HISTORIC AND DESIGN REVIEW COMMISSION

May 18, 2022

HDRC CASE NO: 2022-117
ADDRESS: 527 HAYS ST
LEGAL DESCRIPTION: NCB 529 BLK 2 LOT E 51.12 FT OF S 92.5 FT OF 14
ZONING: R-6, H
CITY COUNCIL DIST.: 2
DISTRICT: Dignowity Hill Historic District
APPLICANT: Megan Suermann/SUERMAN PATRICK & SUERMANN MEGAN
OWNER: Megan Suermann/SUERMAN PATRICK & SUERMANN MEGAN
TYPE OF WORK: Window replacement, shutter installation, exterior alterations, painting
APPLICATION RECEIVED: March 04, 2022
60-DAY REVIEW: Not applicable due to City Council Emergency Orders
CASE MANAGER: Claudia Espinosa

Example of window to be replaced (same size in white vinyl), will convert extra room back into a garage

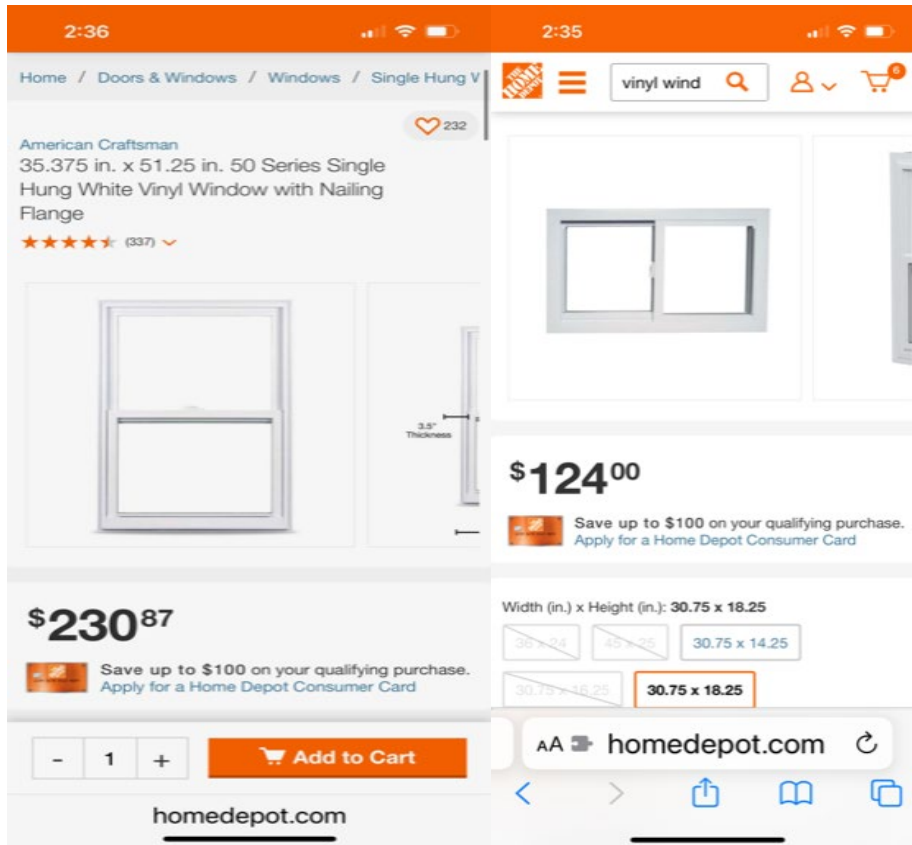
- b. BRICK PAINTING – The applicant has proposed to apply a white lime wash to cover the existing, tan brick. Per the Guidelines for Exterior Maintenance and Alterations 2.A.i., historically unpainted brick surfaces should remain unpainted. The proposed painting/application of limewash is inconsistent with the Guidelines.

- c. WINDOW REPLACEMENT – The applicant has proposed to replace the existing, aluminum windows with new vinyl windows. The windows that have been proposed by the applicant are white, vinyl windows that feature a nailing fin. Staff finds the proposed replacement windows to be inconsistent with the Guidelines and

Damage to brick from settling foundation on right and left side of house

Breathable material I'd like to use over brick after foundation repair to hide cracks to improve aesthetics.

I'd like to replace aluminum windows with white vinyl windows to improve energy efficiency and to improve operability after foundation repair. They will be the same size, no framing required.

- 1. Staff does not recommend approval of item #1, the painting/limewashing of brick, based on finding b. Staff recommends the brick remain unpainted.
- 2. Staff does not recommend approval of item #2, the replacement of the existing, aluminum windows with white vinyl windows, as noted in finding c. Staff recommends that the applicant install windows that are consistent with staff's standards for replacement windows, as noted in the applicable citations.
- 3. Staff does not recommend approval of item #3, the installation of window shutters based on finding d.

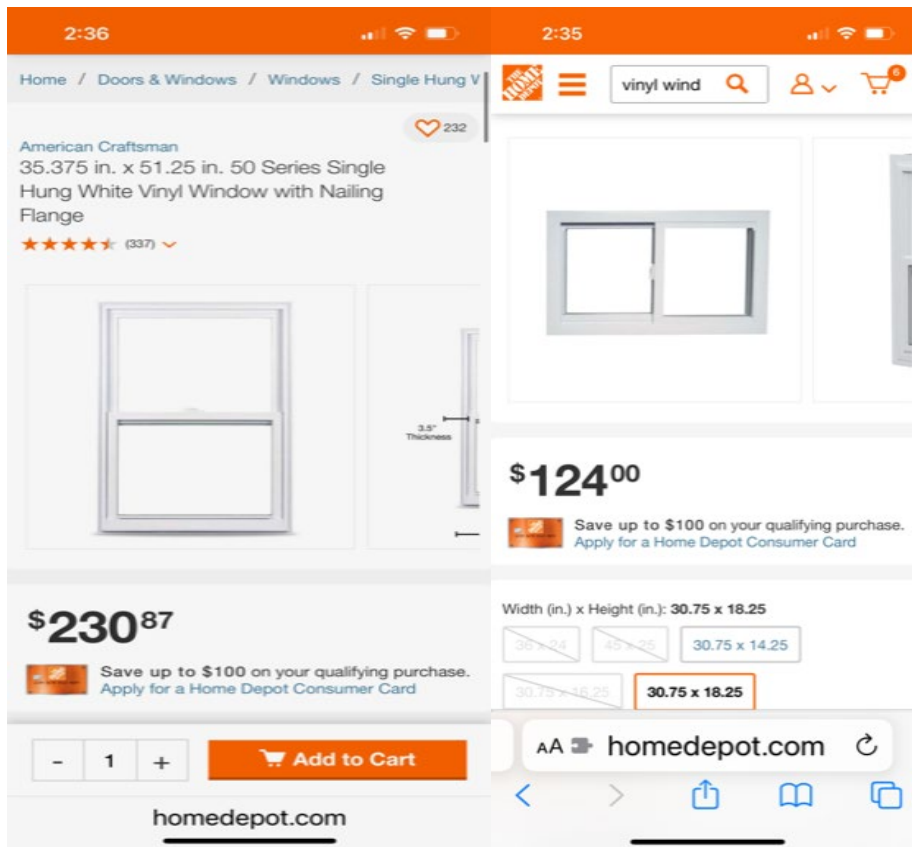
- d. SHUTTER INSTALLATION – The applicant has proposed to install black shutters at the front windows. The Guidelines for Exterior Maintenance and Alterations 6.B.x. notes that shutters should not be installed where they did not historically exist. Staff finds the proposed installation of shutters to be inconsistent with the Guidelines.
- e. PREVIOUS REVIEW & DRC – This request was reviewed on Wednesday, April 20, 2022. The applicant has agreed to:
 - a. Refrain from limewashing the foundation.
 - b. Add shutters to only the front two windows where the front door is.
 - c. Replace windows with an aluminum window with mill finish with anodized or clear finish with two of over two millions.

I'd like to add shutters to the front windows to improve aesthetics. Shutters were very popular mid-century modern exterior. They will be the same height and width as the front windows and appear operational.

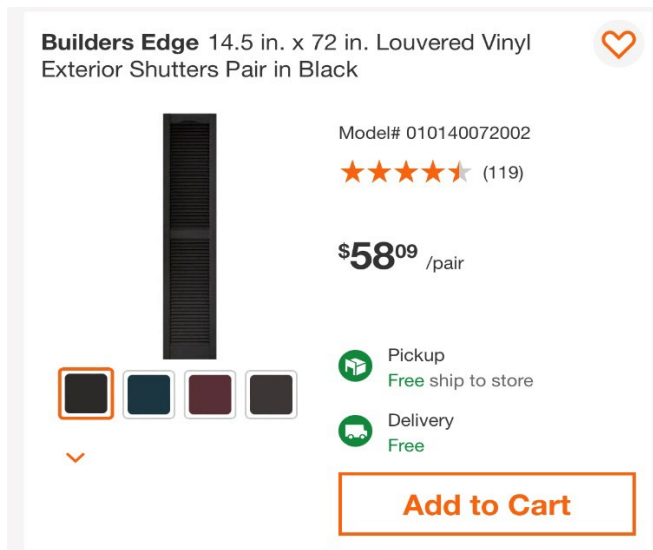
I'd like to replace aluminum windows with white vinyl windows to improve energy efficiency and to improve operability after foundation repair. They will be the same size, no framing required.

I'd like to add shutters to the front windows to improve aesthetics. Shutters were very popular mid-century modern exterior. They will be the same height and width as the front windows and appear operational.
